## **Addendum No. 4**

### **South Dade Regional Library Interior Renovations**

**C23-MDPLS-01-ESP**

**ADDENDUM NO. 4**  
16-JAN-2025

Sheet  
A-9

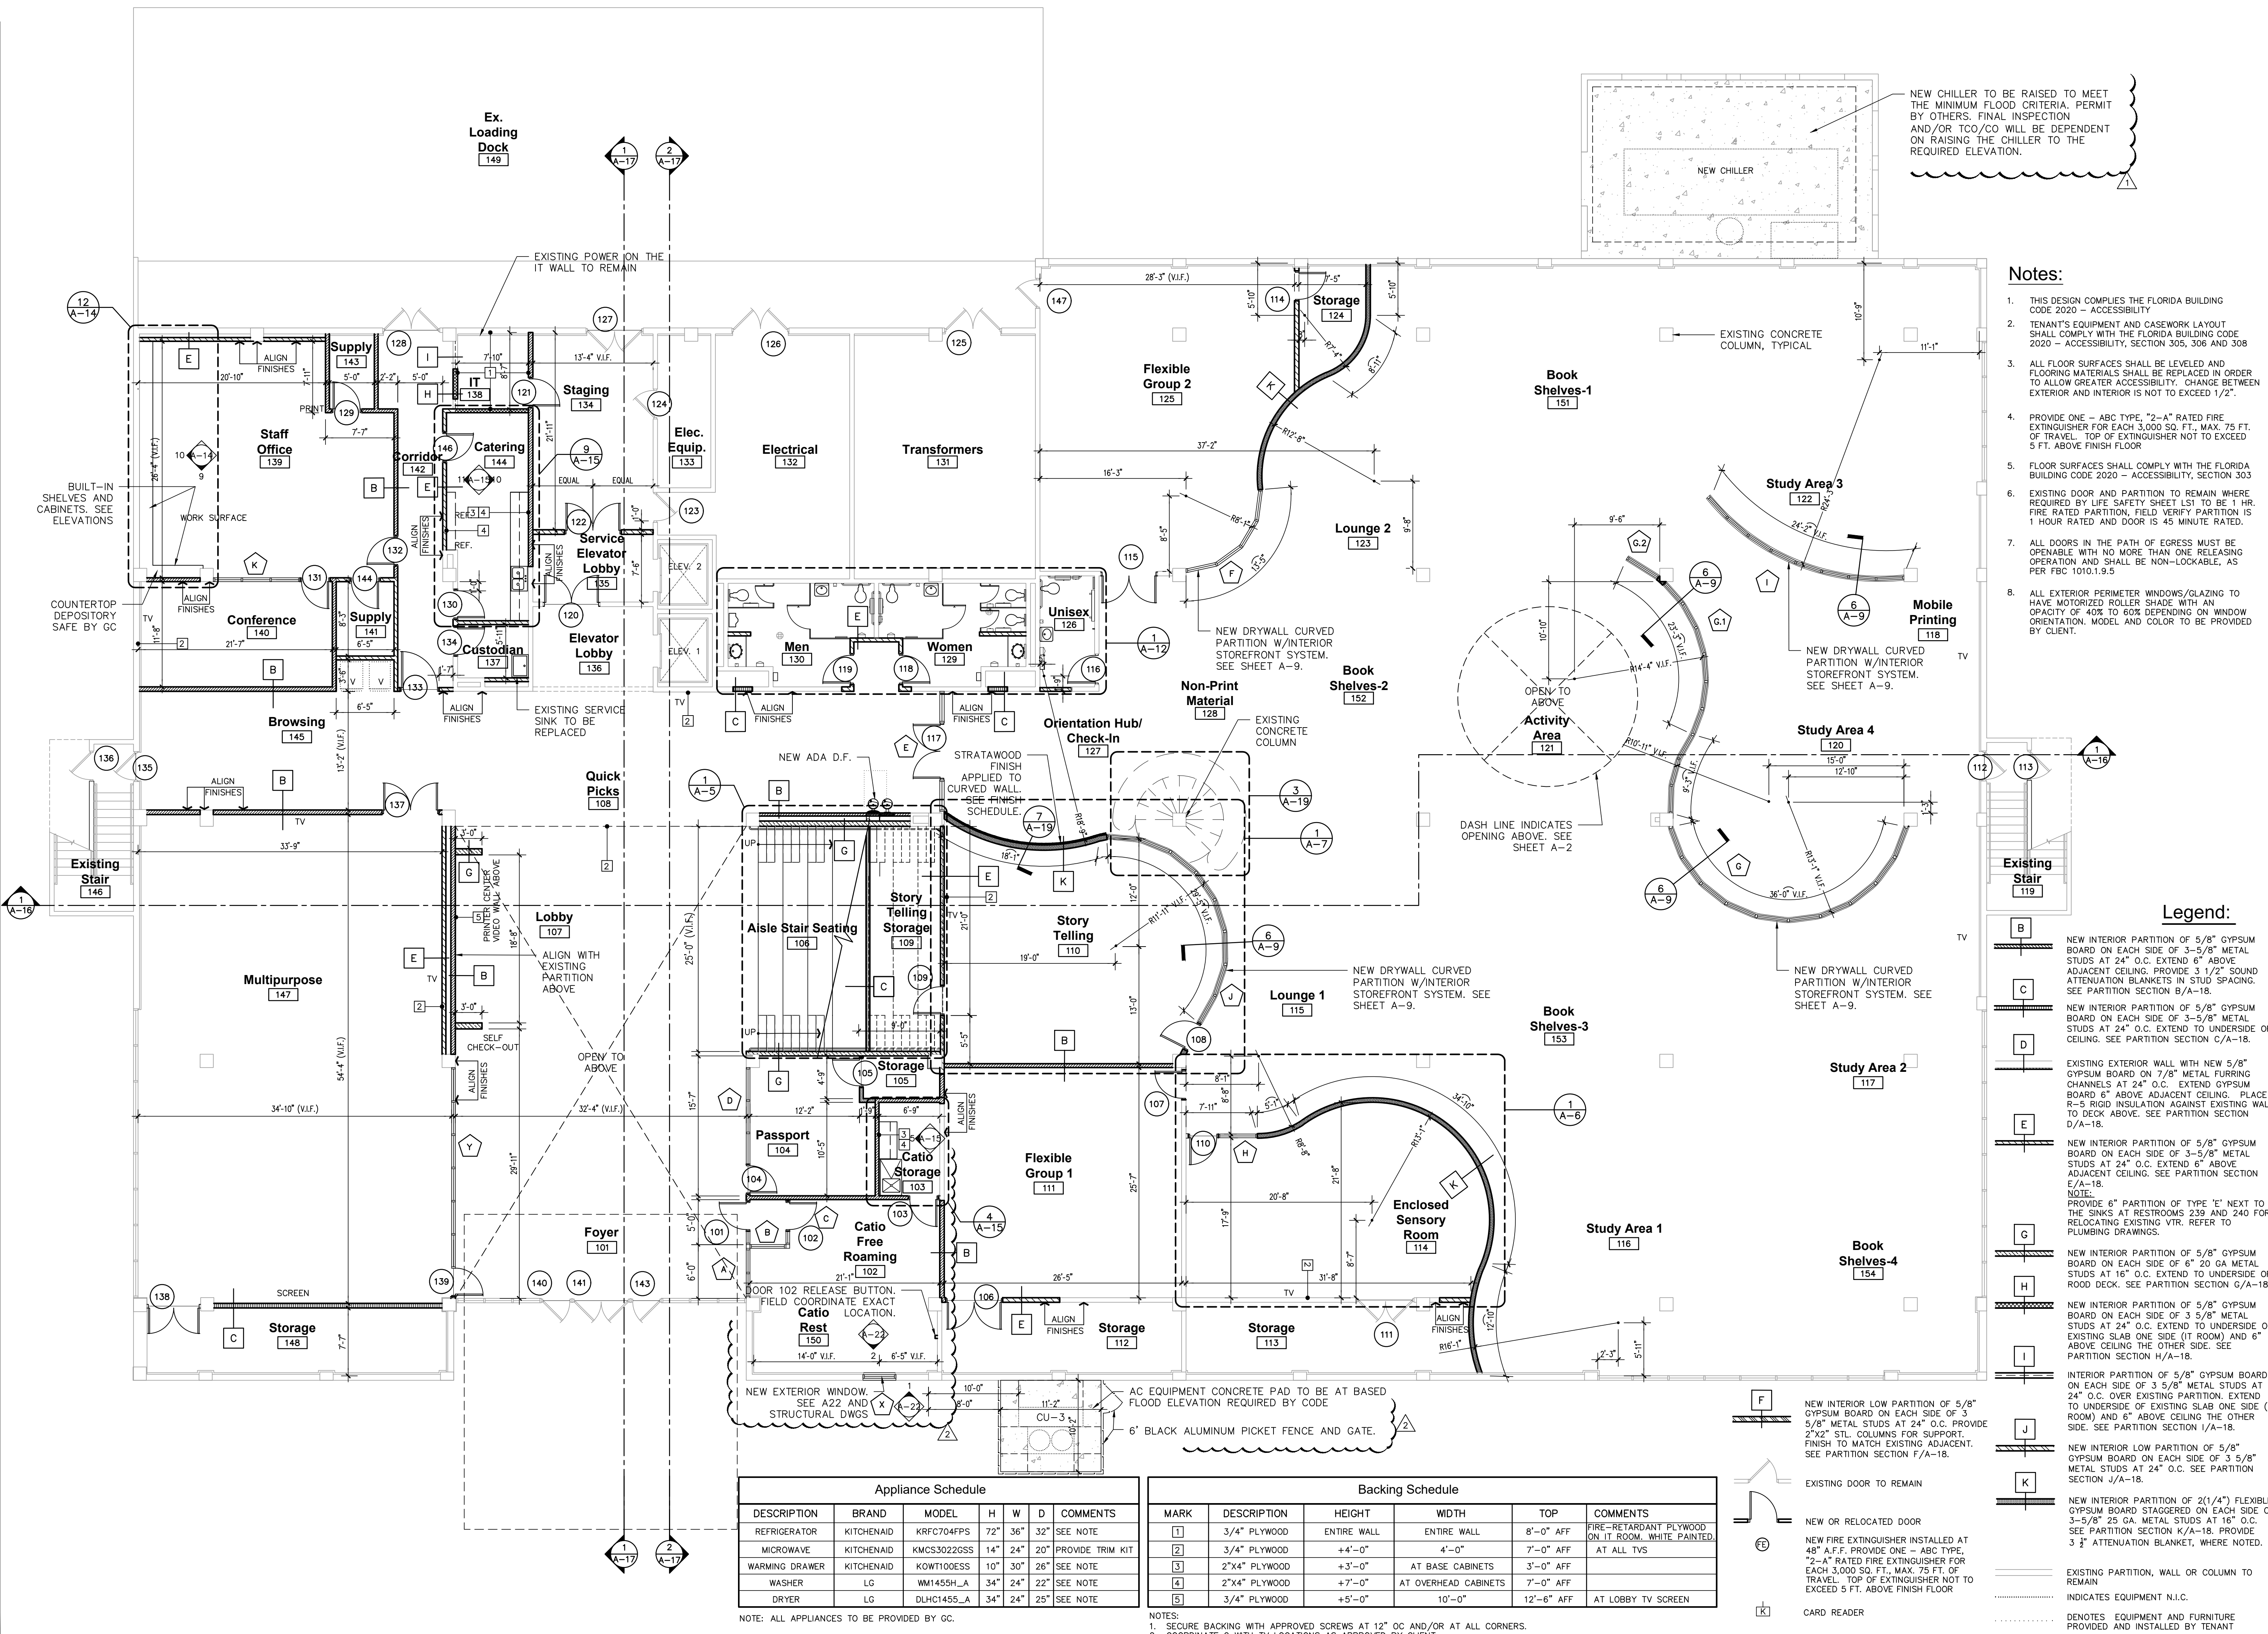
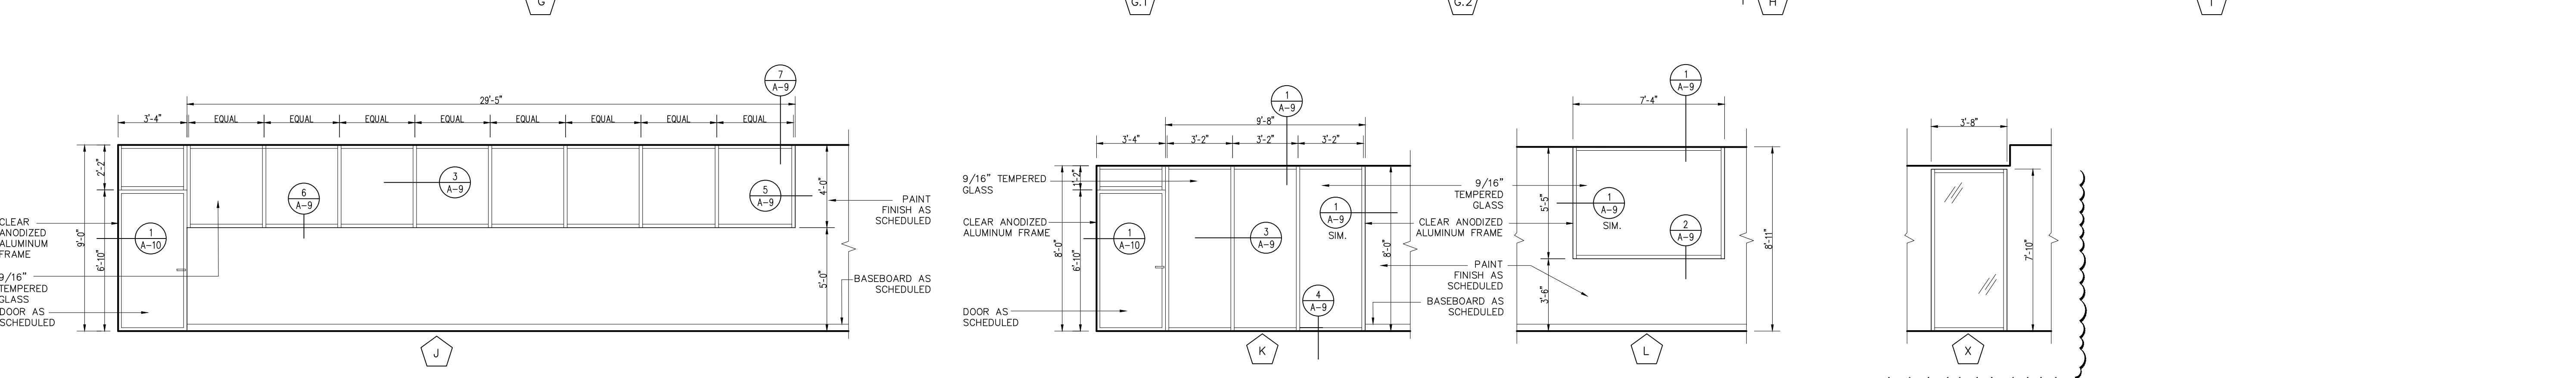
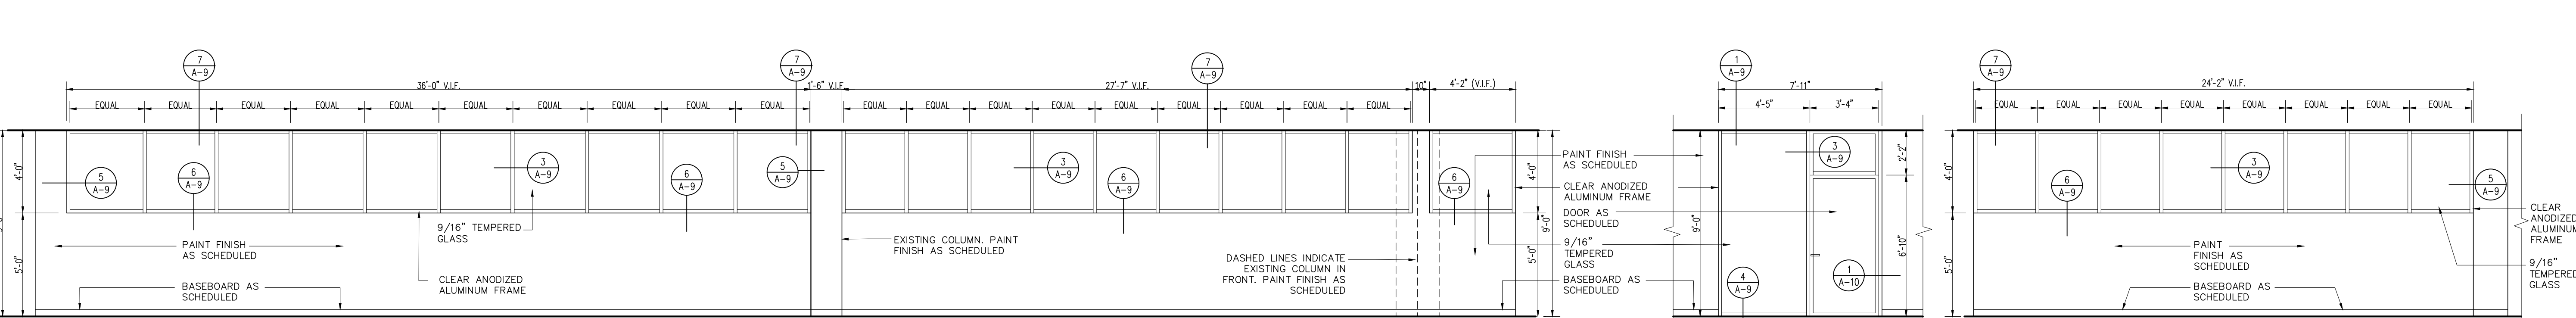
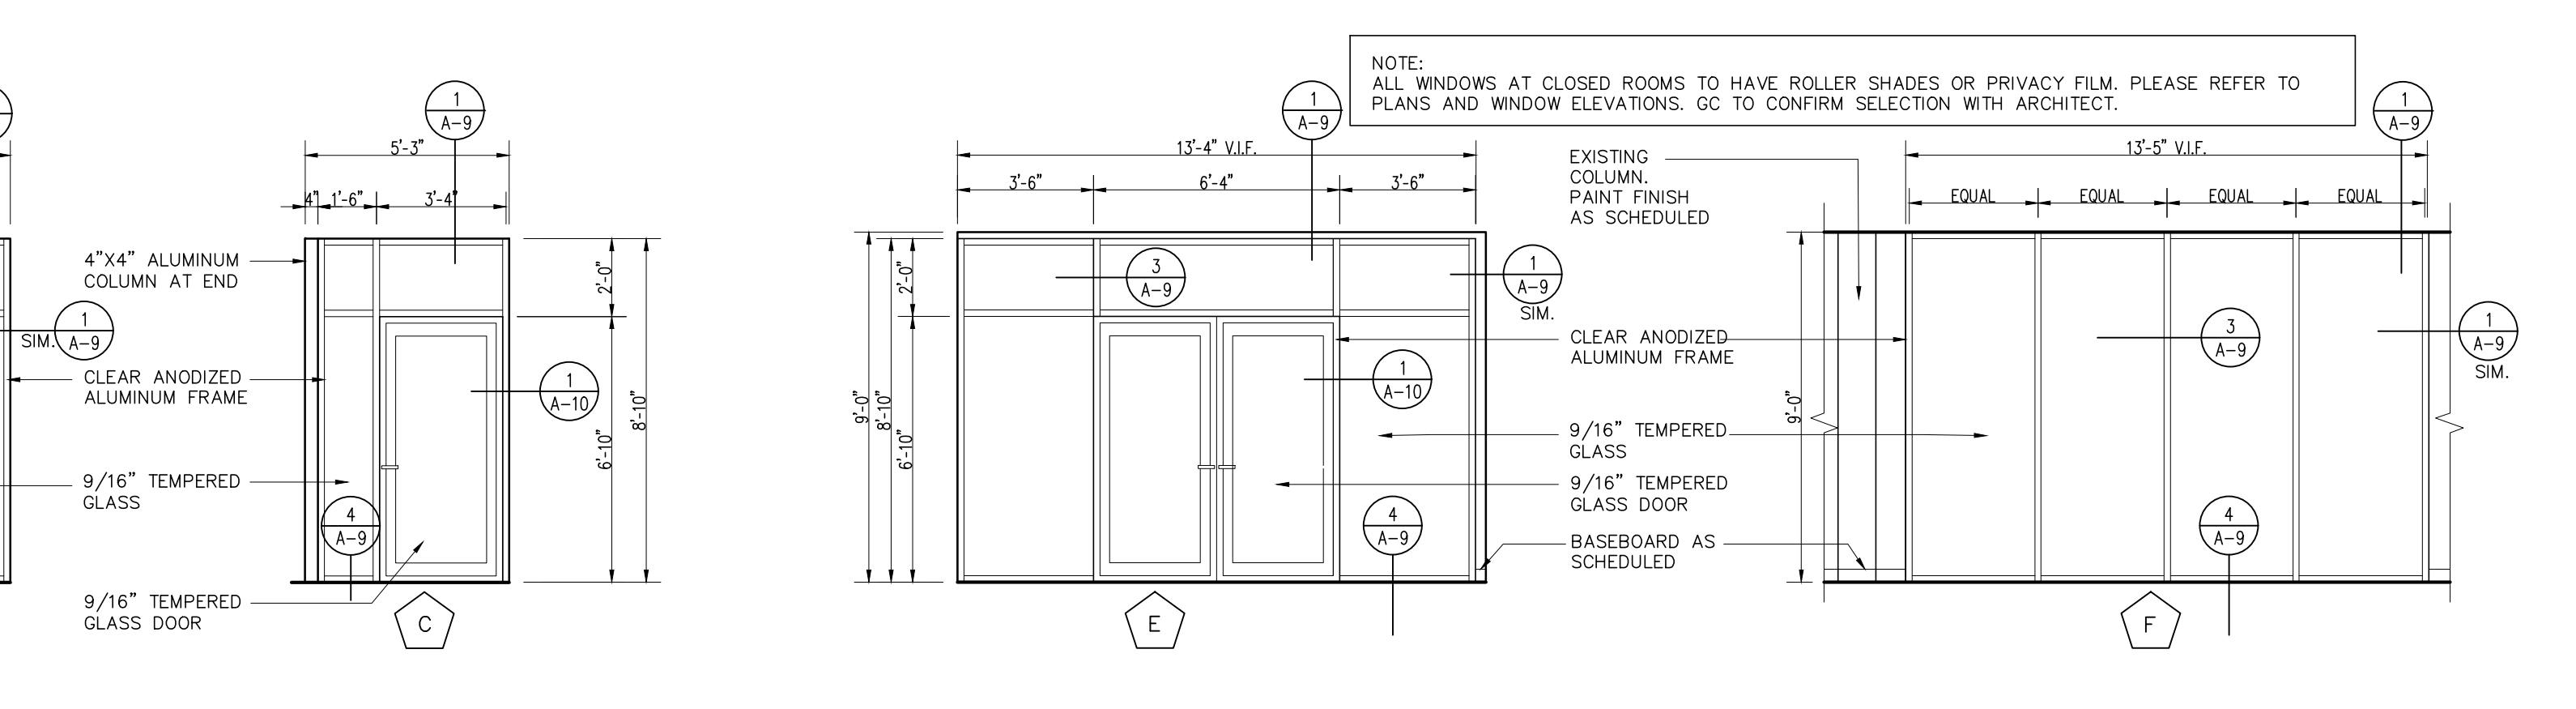
Q47. Plan Sheet A-9 shows the Window Schedule, but it seems to exclude the new Exterior Window shown at plan A-22. Please confirm Exterior window is to be included in Base bid and if so, add to the Window Schedule.

Q48. Plan Sheet A-9 shows an interior window Mark V with a partial window film to be selected by architect. Applied only to 40” high? Please clarify if the film is to be included in Base Bid and if so, provide a specific film selection and color/finish.

**Response Q47. Exterior window should be included in the Base bid. Refer to revised sheet A-9, Window Schedule and window mark on A-1 First Level Floor Plan.**

**Response Q48. Yes, film to be included in the Base bid. Film by Design Film, SKU: DF-GF3-30\_100 or similar. GC to provide samples for client and architect approval prior to ordering.**
